Final Environmental Assessment for the Molten Chloride Reactor Experiment (MCRE) Project

August 2023
INL/RPT-22-68976

Agency and Public Comments Received on the Draft Environmental Assessment and DOE-NE Response

Figure 10. Earthquakes occurring from 1850 to 2020 with magnitudes greater than 2.0.

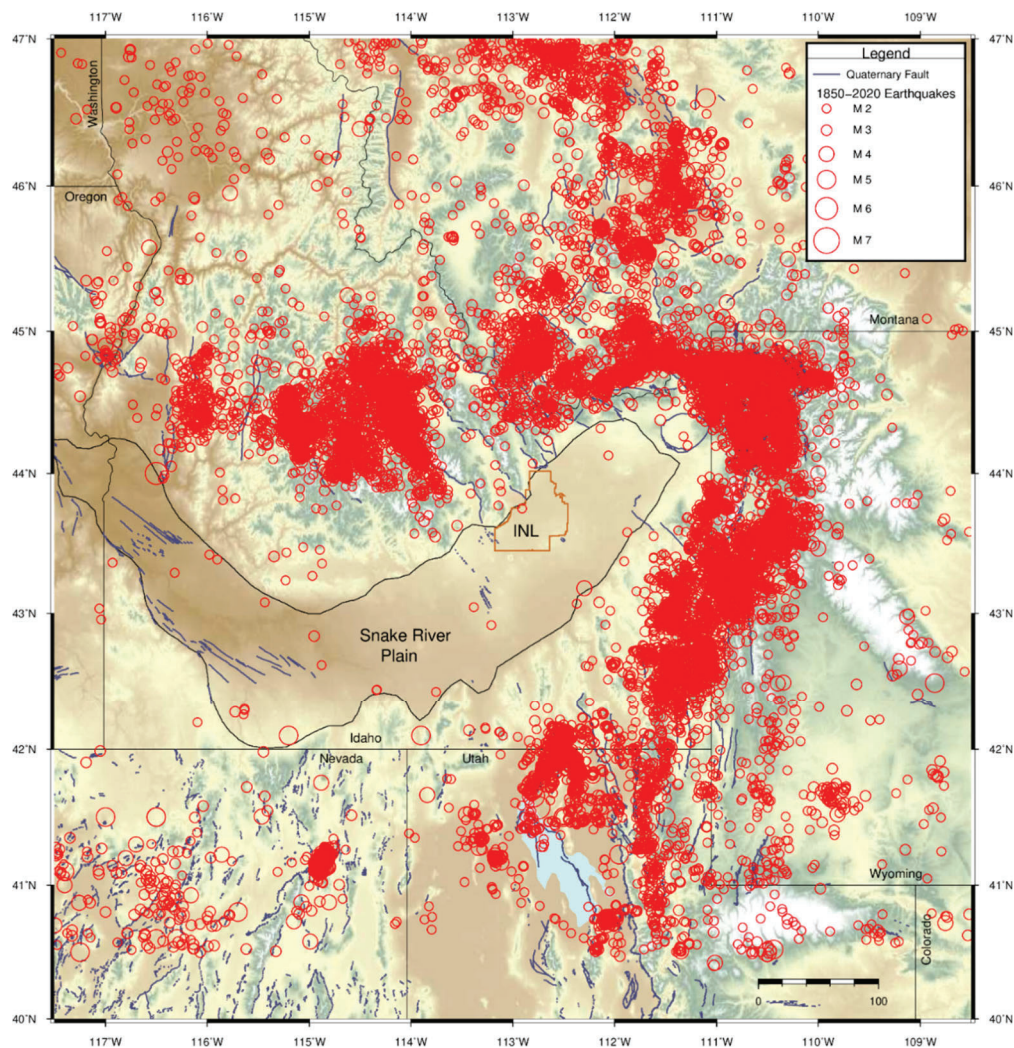
Figure 10, Earthquakes occurring from 1850 to 202 with magnitudes greater than 2.0, shows far fewer earthquakes on the Snake River Plain than the surrounding mountains. It is conveyed that the INL should not be very prone to large seismic events. Despite this, the Idaho National Laboratory is refusing, even for this very small 200-kilowatt reactor, to provide a completed seismic evaluation of the proposed facility that the MCRE will be located in. Nor will the decades of concrete, cable and structural aging be taken into account, likely, if the Department of Energy ever completes a seismic evaluation of the facility at the INL that the experiment will be housed in. The EA simply states that "The evaluation of the ZPPR cell under seismic loads is currently being performed." This is unacceptable and inexcusable. No one has the results of the analysis that is "currently being performed." But, it is "business as usual" for the Idaho National Laboratory and the Department of Energy. Using 150 years of seismic experience is inadequate to conclude that no impacts due to seismic events would occur and DOE knows better.
